BEFORE THE PUBLIC SERVICE COMMISSION
OF THE STATE OF MISSOURI

In the Matter of the Resource Plan of) File No. EO-2013-0537
Kansas City Power & Light Company)

COMMENTS OF SIERRA CLUB

Intervenor Sierra Club hereby submits these comments on the Kansas City Power & Light Company (“KCP&L”) 2013 Integrated Resource Plan (“IRP”) Annual Update Report. Although KCP&L did not make this filing during a triennial compliance year, because the Commission issued an order on December 19, 2012 in Case No. EO-2012-0323 that declined to approve KCP&L’s 2012 IRP and specifically directed the company to address all of the parties’ unresolved deficiencies and concerns in this year’s annual update filing, KCP&L’s 2013 IRP update filing effectively replaces the company’s 2012 IRP and must be judged by the standards that apply to triennial compliance filings.

Figure 4: Annual RAP DSM potential for KCP&L, reproduced from Navigant DSM Study, page 50

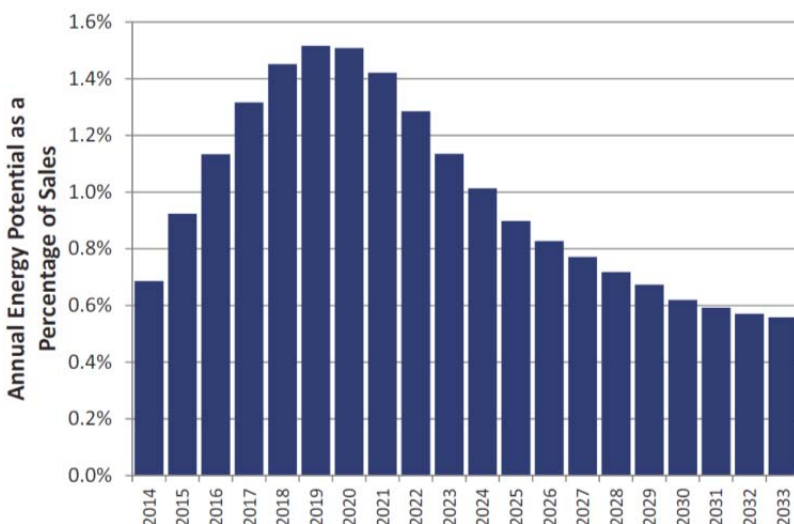
Figure 4 reproduces the Navigant study's annual DSM energy potential for KCP&L's Missouri operations. Per the study, "potential ramps up over the first several years, peaks in about 2020, and tails off in the later years as the market for energy savings saturates and approaches its equilibrium value."¹⁴ According to Navigant, this tail remains positive for several reasons, including the addition of building stock and the rise of avoided costs, which make more measures economic. While the annual energy savings potential peaks and declines, the cumulative potential will continue to grow throughout the study period, provided that energy efficiency measures are replaced at the end of their useful life. The Navigant study's annual DSM energy potential for GMO reaches similar conclusions.

Figure 5: Annual DSM energy for RAP and MEEIA-RAP alternatives

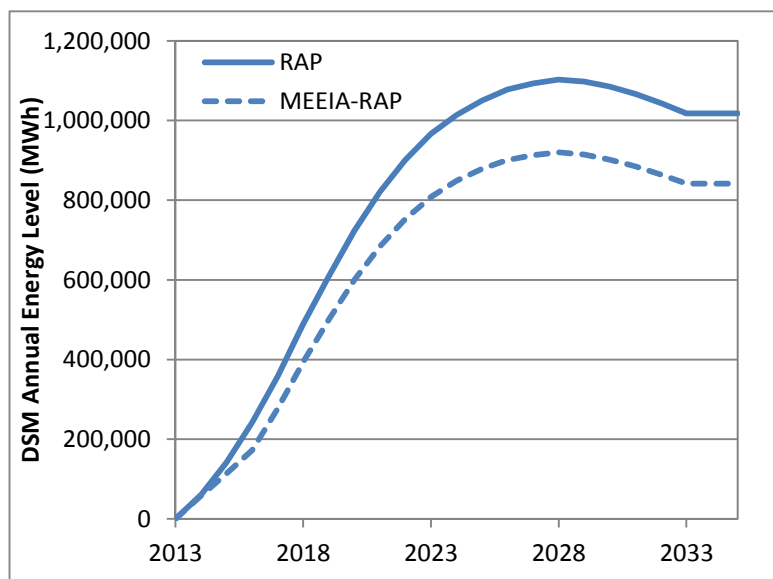
KCP&L’s adjusted MEEIA-RAP forecast is compared to RAP in Figure 5. The reduced spending over a few early years cascades forward, resulting in substantially less cumulative DSM energy savings over the study period. This difference results in the substantial difference in costs and rates of the two plans discussed above.

KCP&L also adjusted the Navigant study downward based on the assumption that 15 percent of C&I customers will opt out of lower-cost DSM, as this is the percentage of GMO customers that have historically requested to opt out. This assumption is not adequately justified. Is the 15 percent opt-out for GMO based on a single year, or several? Perhaps the GMO DSM deployment did not include programs that were appealing to C&I customers, causing them to opt out, which the KCP&L program could improve on. In fact, data from EIA Form 861 indicates individual KCP&L industrial customers use substantially less energy than GMO customers—1,450 MWh per customer per year at KCP&L compared to 5,416 MWh per customer per year at GMO. This large difference in the average energy intensity of respective commercial and industrial customers suggests that using the same opt-out rate for both companies may not be a reasonable assumption.

Figure 6: DSM capacity from Navigant Report and KCP&L's plans

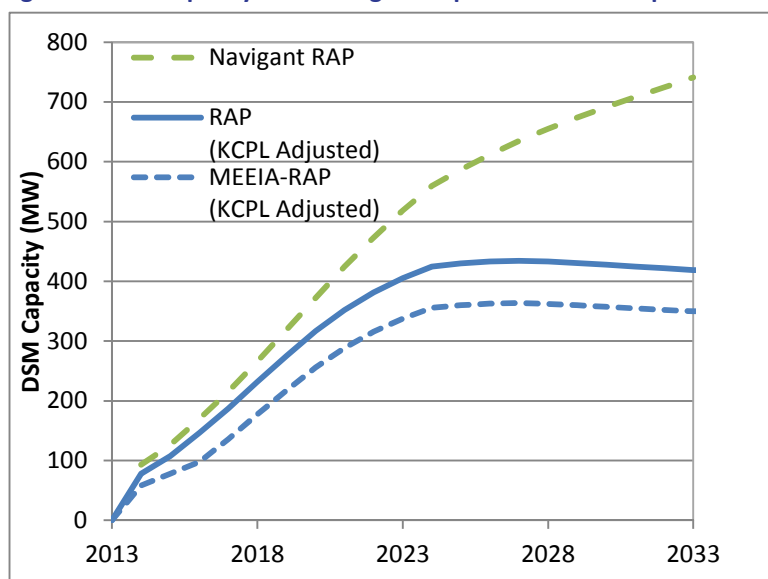
In addition to being an essential low-cost energy resource, DSM also provides demand savings in the form of peak reductions. The cumulative demand savings potential from the Navigant study (Appendix L) grows every year, as shown in Figure 6, eventually rising to a total of 741 MW for KCP&L in the RAP scenario, including energy efficiency (EE), demand response (DR), and combined heat and power (CHP). KCP&L's Stakeholder Report (Appendix B) shows a peak DSM capacity of only 432 MW for the RAP scenario, and 363 MW for the MEEIA-RAP scenario. After the peak year in 2026, the capacity savings associated with DSM flattens and subsequently declines. It is unclear why this decline exists, given the Navigant study's finding of a steadily increasing potential out to 2033. While Navigant shows annual savings may decline as the market becomes more saturated (as indicated for energy in Figure 5), cumulative capacity should continue to increase.
